Accessibility Survey

City of Downey Farm Street - Birchdale Avenue to Bellder Drive

Date of Inspection
7/28/2017

Prepared By
Disability Access Consultants
(800) 743-7067

Change in Level West of Paramount Boulevard @ 33.950640272590, - 118.133042603731

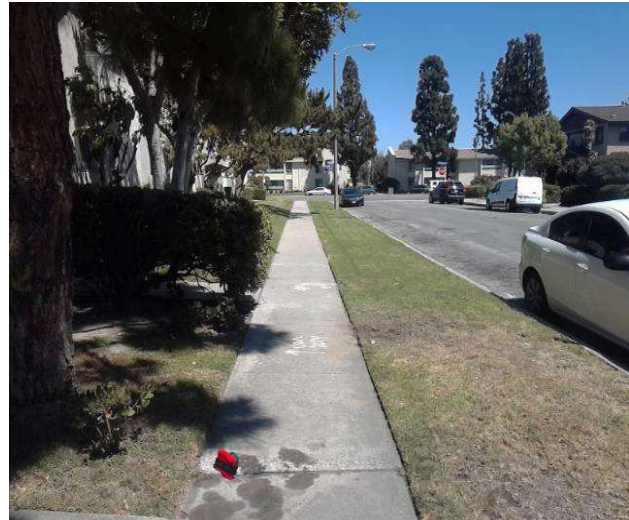
Sidewalks , Change in Level : Change in Level Non Beveled

There is a change in elevation greater than recommended value.

On-Site Finding 0.75 inches

Ensure that the change in elevation is within the recommended value.

Recommendation Up to 0.25 inches
